**RE:** 934 Ocean Avenue – Dragon Products Company

RECORD OF SITE VISIT

1. Date / Time: 10-4-06	
2. Client / Project <b>Dragon Products Company - Ocean Avenue Batch Plant - Roof Repairs</b>	
3. Project Number: 343-020	
4. <b>Who was contacted at the site:</b> (name and firm) Emile- Keeley Construction, Kermit - Dragon Products

Portland Batch Plant Roof Collapse – Stabilization of Existing Structure

Subject: TEMPORARY WALL BRACING DETAIL

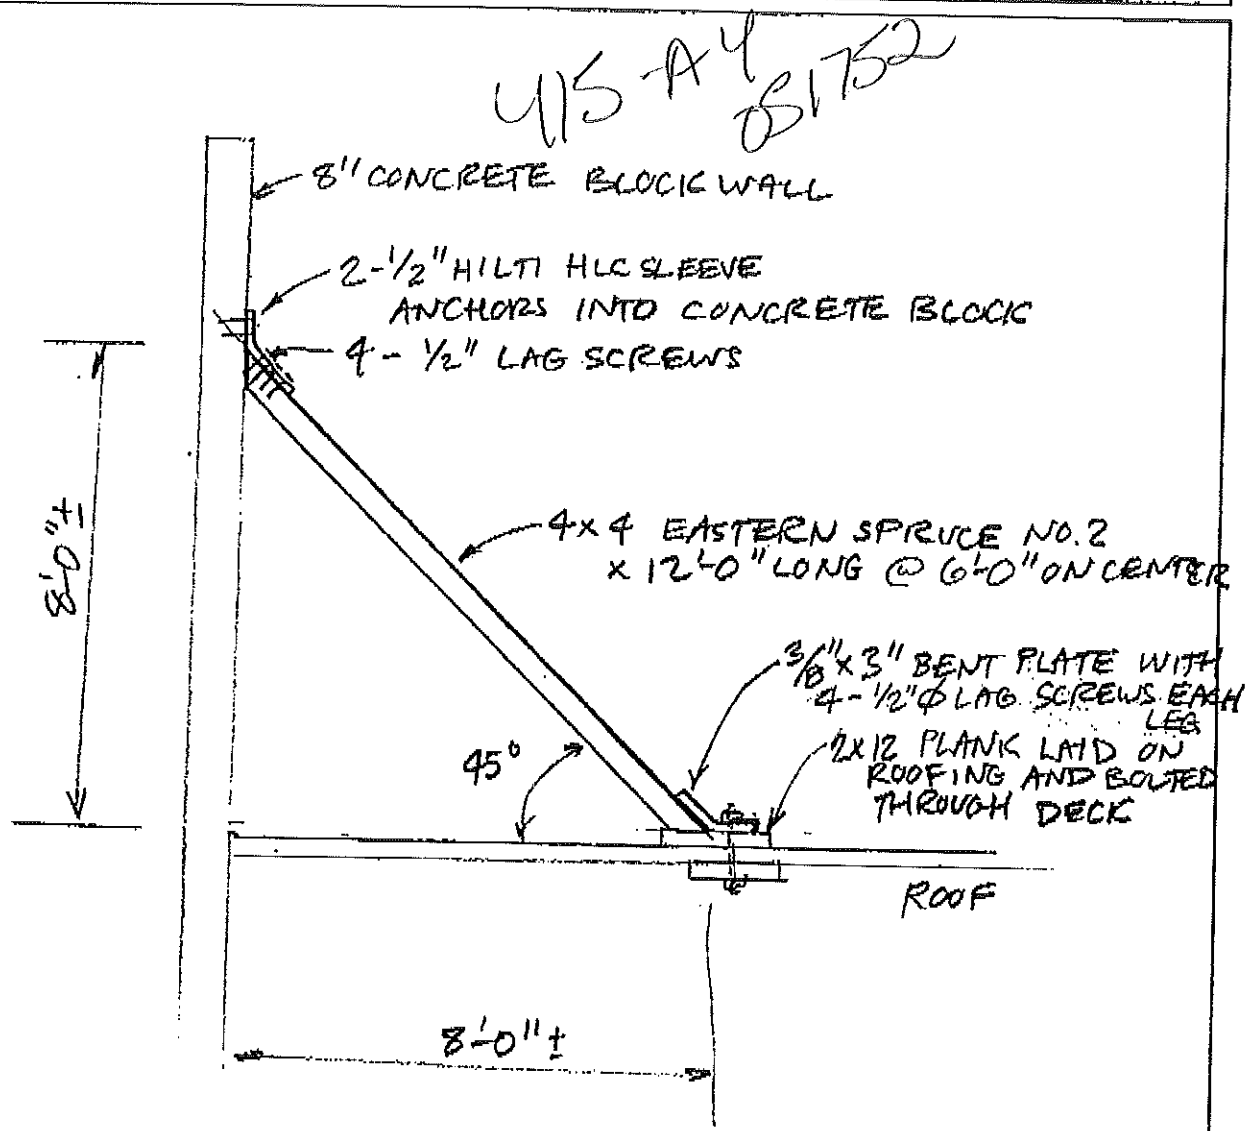
2. Stabilization of the masonry wall on the garage side of the structure.

Our recommendation was to install a standard construction pipe scaffolding along this wall, sitting on the lower roof of the garage, and bolt the wall to the scaffolding as a measure to stabilize it against wind or other lateral loading. We didn't determine the exact details for attachment but a through bolt and plate washer installed through the wall at each frame of the scaffolding, near the top, should be adequate. The scaffolding legs can sit on two rows of wood planks laid over the roof. The scaffolding will also allow access for removal of debris and for working on the edge of the new roof when that is installed.

Scale	AS SHOWN	DRAGON PRODUCTS COMPANY, INC. PORTLAND, MAINE	PRELIMINARY
Project No.	343-030	PORTLAND BATCH PLANT ROOF REPAIRS	
Revision	2006	PLAN AND SECTION OPTION 1	1
Checked By	STR		
Drawn By	TLT		
Checked By	STR		
NA	Revised	Date	Rev. Number 11-28-05

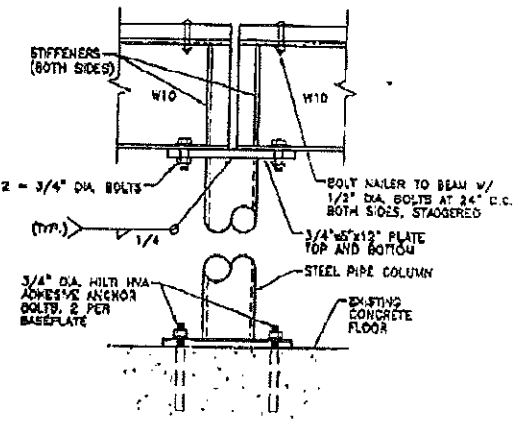
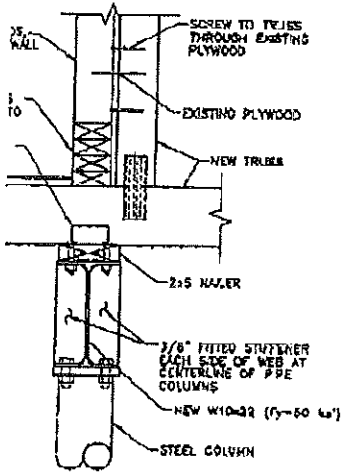
I am enclosing a preliminary Kleinschmidt drawing of final roof repairs to our building that shows the temporary 4x4 posts from the cupola wall header to a steel flange on the steel aggregate bins of the batch plant. The 4x4s will be installed, as per Kleinschmidt's recommendation, at each roof truss to the steel flange on the aggregate bins, where a bracket will be welded to encompass each 4x4. This shoring will be left in place through clean up and final repairs to the building that is to be approved by you at a later date.
